AMENDMENTS TO THE DRAWINGS

REMARKS

ANNOTATED SHEET
APPLICATION SERIAL NO. 10/730,281

FIG. 5

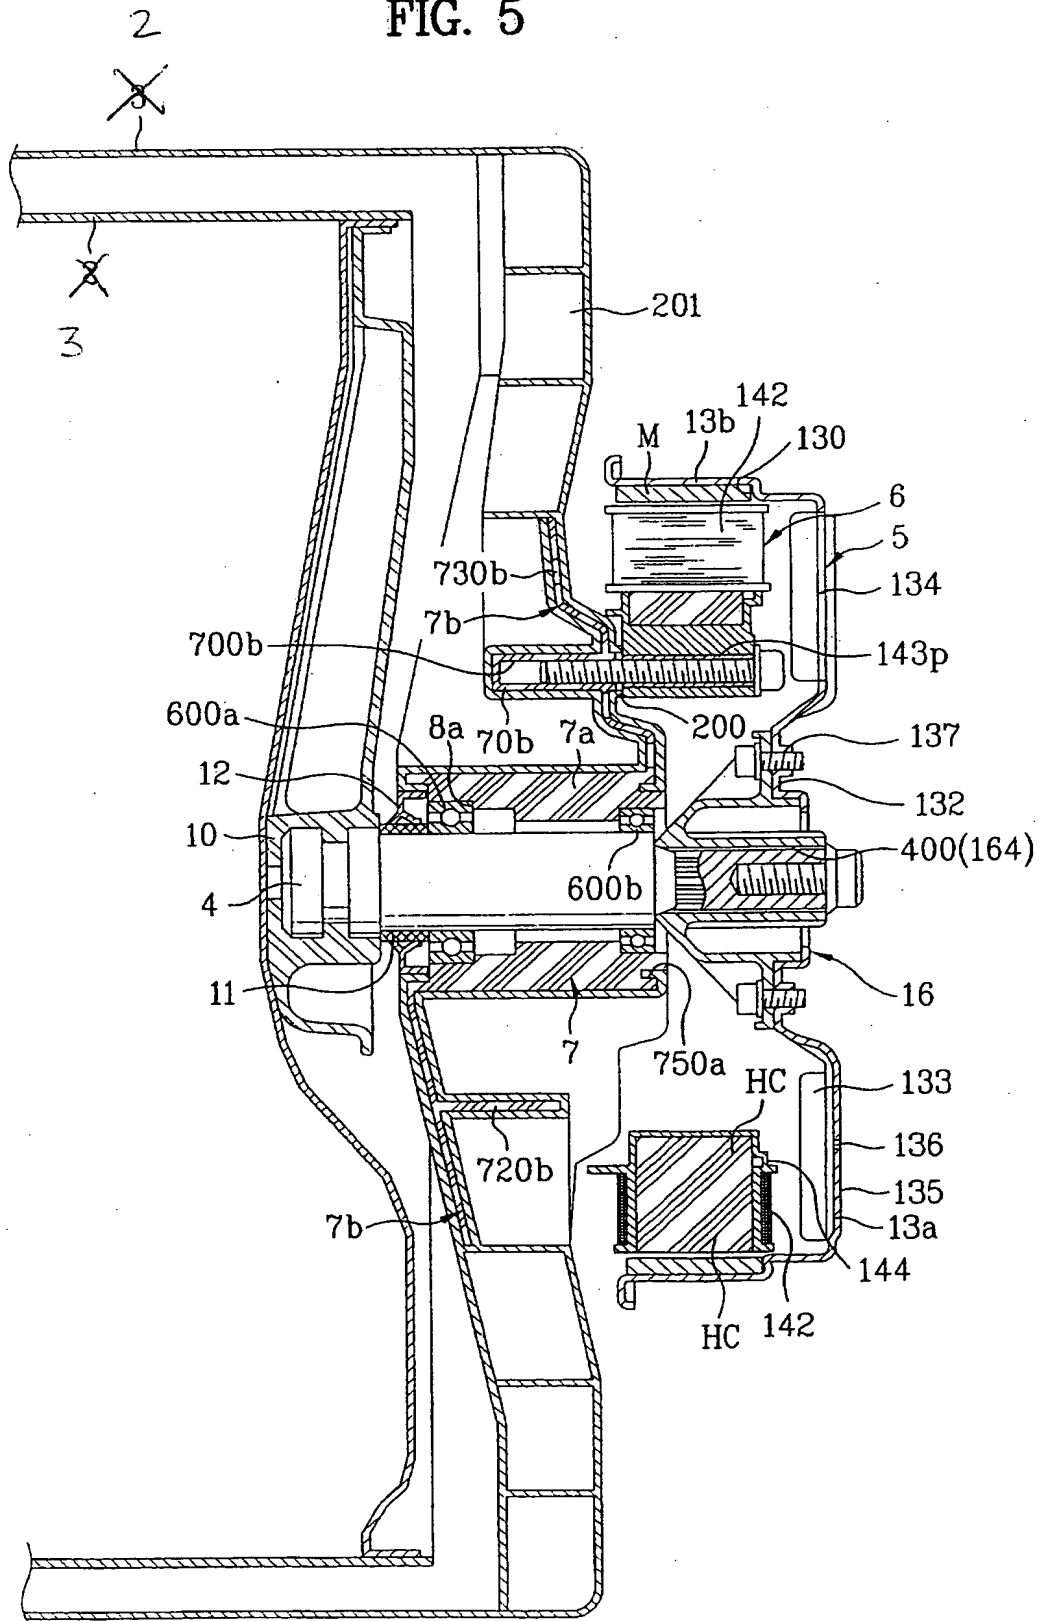
In Figures 5 and 14, the reference labels “3” have been amended to --2--, while the reference labels “2” have been amended to --3--.

Please replace original Figures 5 and 14 with amended Figures 5 and 14 of the attached replacement sheets.
